CAPRICORN MUNICIPAL DEVELOPMENT GUIDELINES

2022 MEETING 04 Minutes

D05.18. PIPE MATERIAL

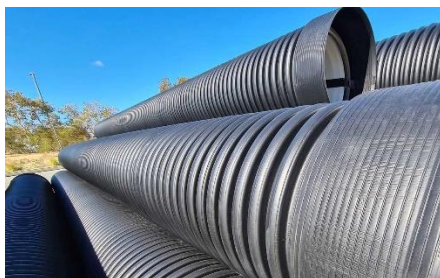
- LSC is suggesting use of corrugated polypropylene drainage pipes.

- C221 Section C221.04 mentions FRC and RCP pipes but not Plastic.
- Current Section D05.18 reads as follows.

- It is noted that Hydra Storm supplies pipe as follows:
 - Manufactured in accordance to AS – NZS 5065
 - Available from Diameter Nominal (DN) 225mm to 600mm
 - Manufactured from recycled HDPE

- C221 will need to be updated at the same time as D5.
- Richard mentioned that he is meeting with a representative from Iplex next week where he will get additional information and specifications.

- Richard has met with the sales Rep but proposed changes to D5 and C221 are still being considered. It is recommended that Polypropylene pipes with classification SN8 are approved up to a diameter of 600mm.
- The technical guide for Blackmax (Iplex) is included as **Attachment Q**.

Update D5 and C221 to permit polypropylene pipes (SN8) up to 600mm diameter. Revised documents to be sent to committee for review.
